SERVICE LETTER

SL-121619 REV A

DATE ISSUED: 1/13/2020
DATE EFFECTIVE: 1/16/2020
SUPERSEDES NOTICE: N/A
SUBJECT: Optional Improvement - Removal and Replacement of Wing Hang Pins
AIRCRAFT AFFECTED: **MODEL:** A5
S/N: ASN 1, 2, 5, 6, 9, 12, 15, 17, 18, 20, 23-34, 36, 38, 40-43, 45-47, 49, 50, 52-72, 74, 76-97, 99-101, 103-108

Figure 1: Wing Hang Pin Install

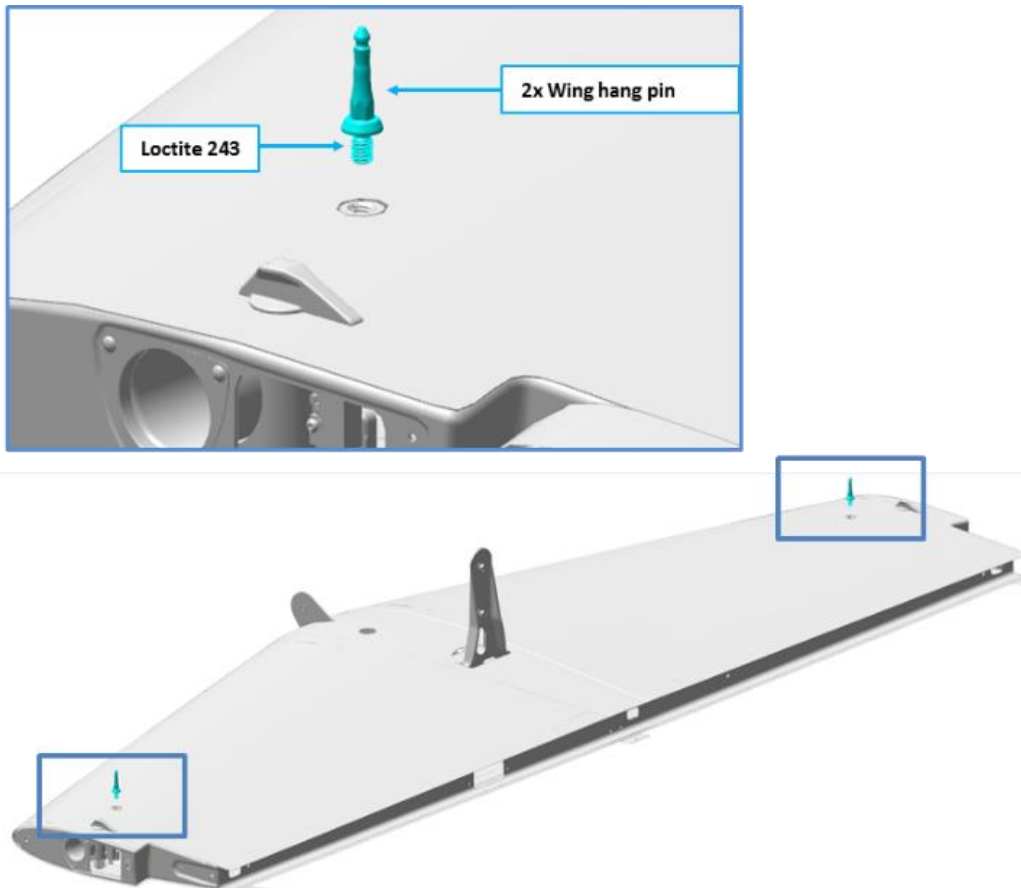
ICON is committed to designing, manufacturing, delivering, and supporting a high-quality Light Sport Aircraft. This Service Letter is to notify owners of an upgraded Wing Hang Pin made from a material that reduces fatigue and increases the life of the pin. This notification includes instructions for replacing the Wing Hang Pins.

2. ____ Apply Loctite 243 onto the threads of the new wing hang pin, Figure 1.
3. ____ Install new wing hang pins (ICA013760) into the Horizontal Tail.

4. ____ Torque wing hang pin to **150 inch-lb.**
